SERVICE INFORMATION NO. SI 36-074

Rotax Service Bulletin ASB 912-060 and ASB 914-043

CHECKING OF THE OIL PUMP FIXING BOLTS FOR CORRECT TORQUE FOR ROTAX® ENGINE TYPE 912 AND 914 (SERIES)

ASB-912-060

Fig. 1
Oil pump 912/914 Series

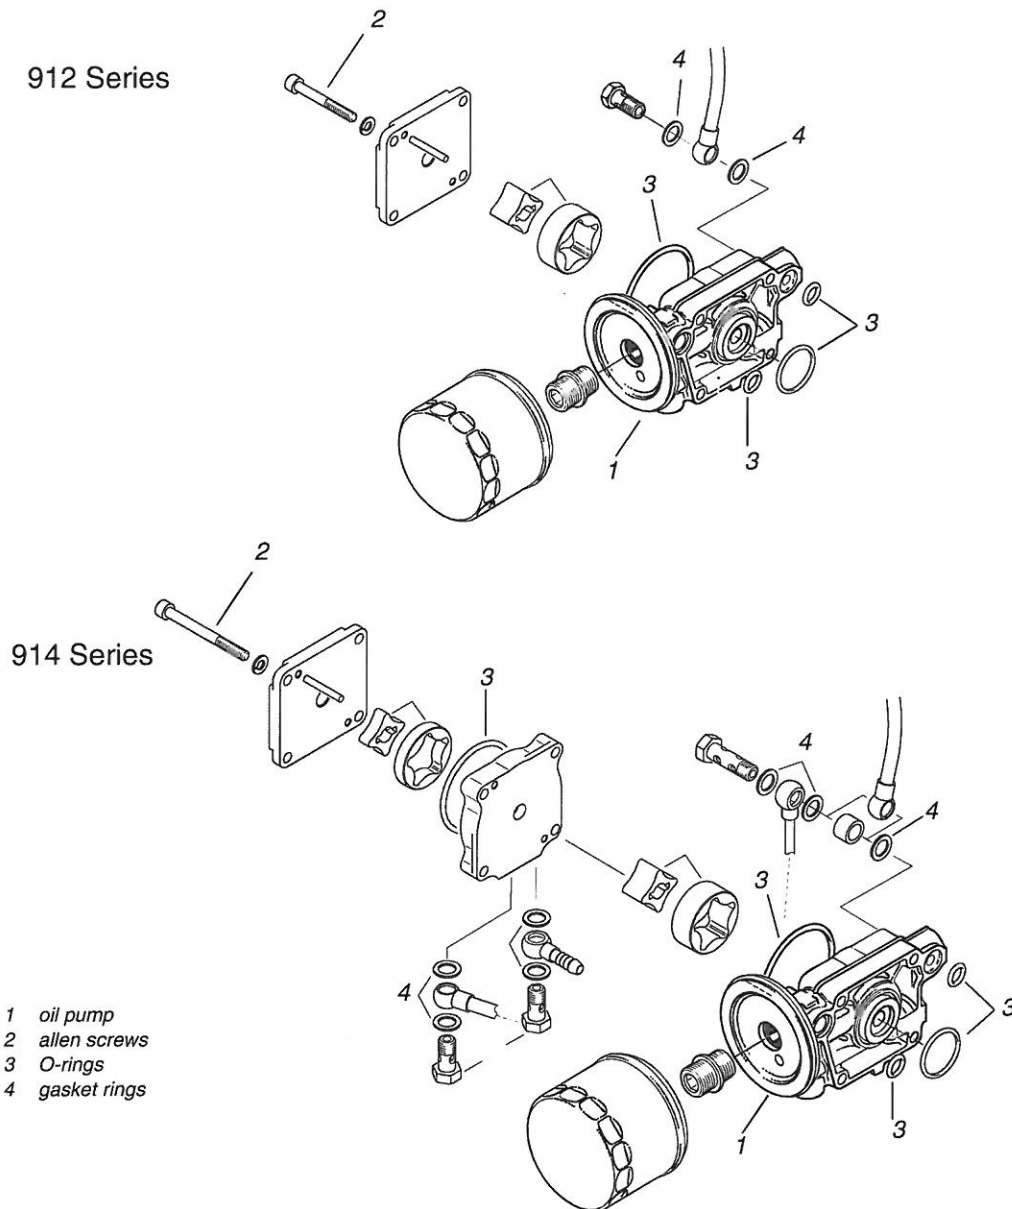
1. Perform inspection for oil leaks in the area of the oil pump. See fig. 1.
2. If you notice oil leaks then all following tasks have to be performed from section 3.1.1 to 3.3 inclusive.
3. If you notice no oil leaks then only the section 3.1.1 need to be performed.

1. Check and/or tighten the 4 oil pump (1) allen screws (2) with lock washer to 10 Nm (90 in.lb.).

1. Remove the oil pump in accordance with the relevant Maintenance Manual (Heavy).
2. Inspect the surfaces for wear, cracks or damages.
3. Replace all O-rings (3) and gasket rings (4). Spare and replacement parts should be ordered using the current Illustrated Parts Catalog.
4. Install the oil pump in accordance with the relevant Maintenance Manual (Heavy).

Fig. 2
valve train

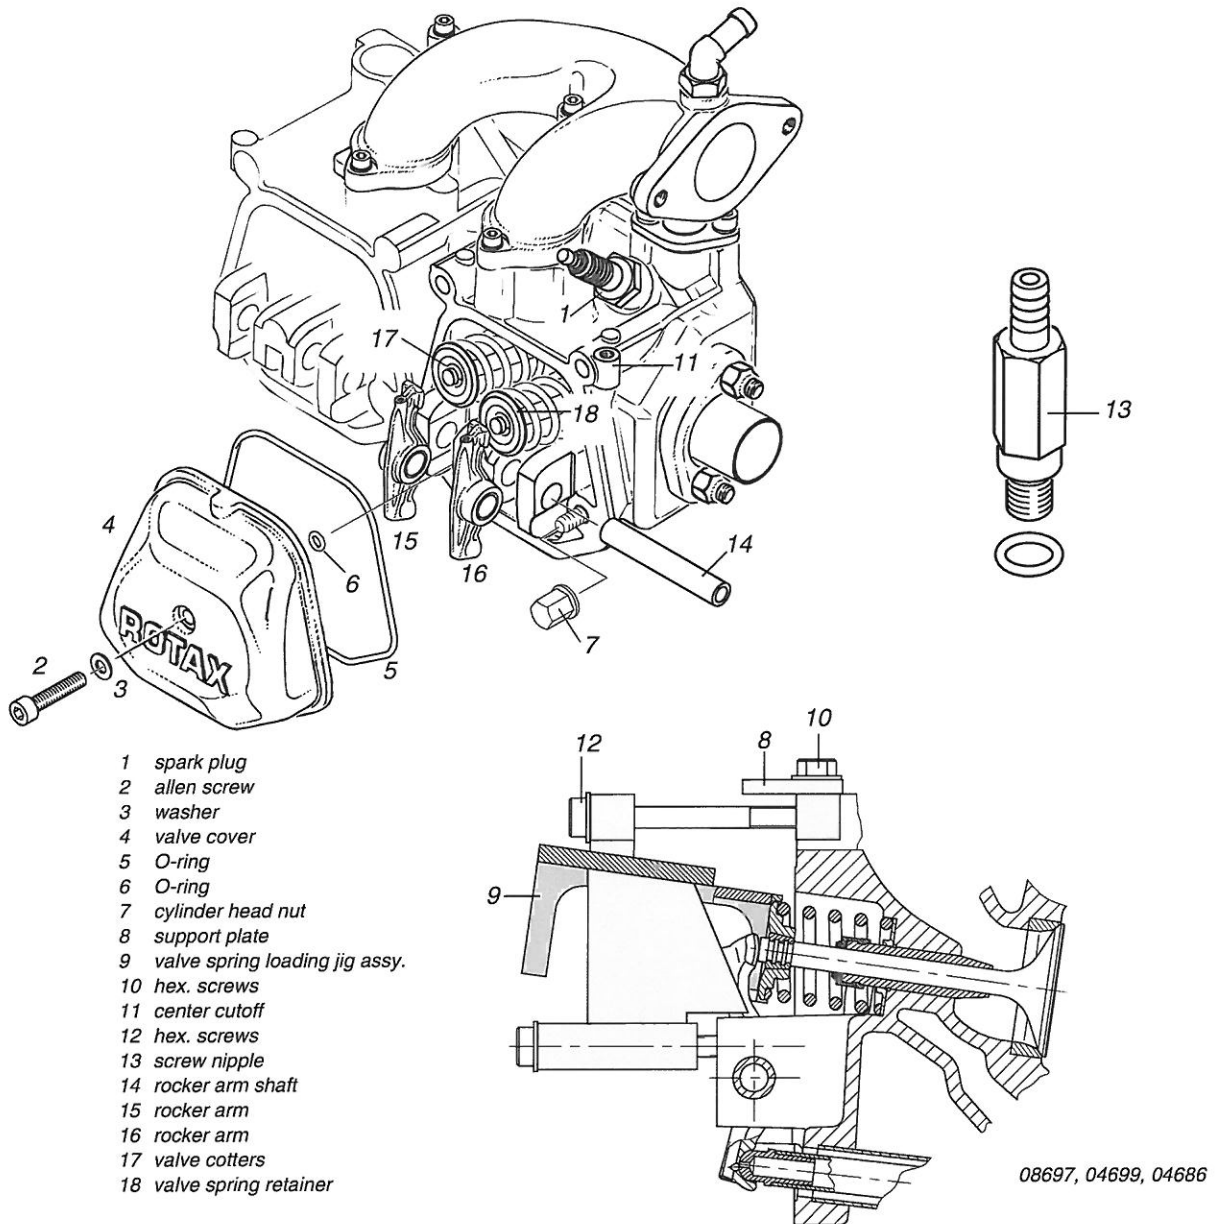
See fig. 2.

2. Remove Allen screw (2) M6x30 with washer (3) from valve cover (4).
3. Remove large and small O-ring (5) and (6).
4. Tap valve spring retainers slightly with a soft mallet to loosen valve spring retainers from the valve cotteners.
5. Turn crankshaft so that the respective piston is exactly on ignition top dead centre (compression stroke).
6. Remove the external cap nut (7) (exhaust side of cylinder).

1. Insert the washers.
2. Insert the inlet- and outlet valve springs.
3. Re-fit the valve spring loading jig assy (9) analogous to procedure for removal of the valve spring retainers.
4. Depress the 2 valve springs evenly by screwing in the 2 Allen screws (12) until the valve cotters can be inserted.

11. Remove the valve spring loading jig (9) and the support plate (8).
12. Re-install cylinder head nut as per current Maintenance Manual.
13. Verify proper fit of the valve cotters and secure fit in valve spring retainer by tapping with a soft mallet.
14. Lubricate all moving parts in the rocker arm space.
15. Clean the sealing surface of cylinder head and valve cover.
16. Insert new O-ring (5) 105x2,5 and O-ring (6) 6,4x1,8 into the valve cover (4).
17. Fit valve cover.

18. Tighten the new Allen screw (2) M6x30 with washer (3) to 10 Nm (90 in.lb.).
